## QUALITY ASSURANCE -- NON-CONFORMANCE REPORT

**Report No:** NCR-000690

<b>Welding</b>	<b>Concrete</b>	<b>Other</b>	
<b>Welding</b>	<b>Curing</b>	<b>Procedural</b>	<b>Bridge No:</b> 34-0006
<b>Joint fit-up</b>	<b>Coating</b>	<b>Other</b>	<b>Component:</b> Segment 5BW/5CW U-Rib Splicing
<b>Procedural</b>	<b>Procedural</b>	<b>Description:</b>

**Reference Description:** Tightening the Bolts of U-Rib Splices not conforming to the approved procedure (Segment 5BW to 5CW)

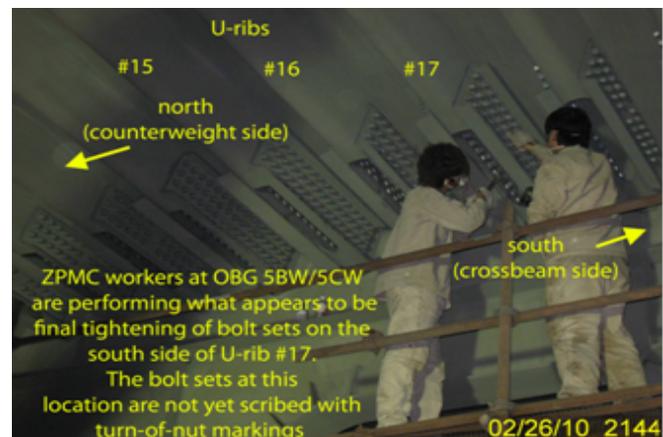
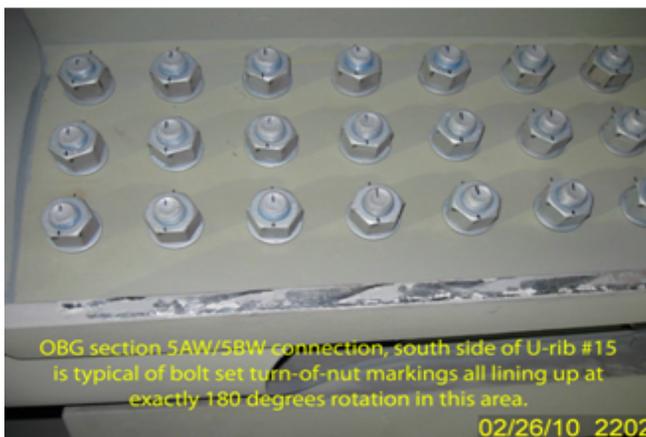
During in process inspection in OBG 5BW/5CW, Caltrans OSM Quality Assurance Inspector observed that the tightening of the bolts were not performed per the approved procedure.

- Marking bolts after final tension had been applied at U-rib #17 (see picture).
- ZPMC workers were performing final bolt tightening of ASTM A325 bolts by turn-of-nut specification of 180° to 210°.
- This issue is located at 5BW/5CW transverse seam at the deck plate U-rib stiffener splice plates.

**Reference Resolution:** All the bolts in U ribs on the North and South sides of #15,16, and 17 in OBG Lift 5BW/5CW were tested to ensure that they met the required torque of 435N\*M for tension verification.

All the bolts in U ribs on the North and South sides of #15,16, and 17 in OBG Lift 5BW/5CW were tested to ensure that they met the required torque of 435N\*M for tension verification. No nut or bolt was turned relative to its matching component by application of required torque. The verification was successful and on the approved bolting procedure and witnessed by a CT inspector, lot number B279. The proper bolting procedure has been reviewed with the bolting crew in question and ZPMC has issued an internal NCR. Based on this ZPMC requests closure of this NCR.

The documentation received is sufficient to close this NCR.
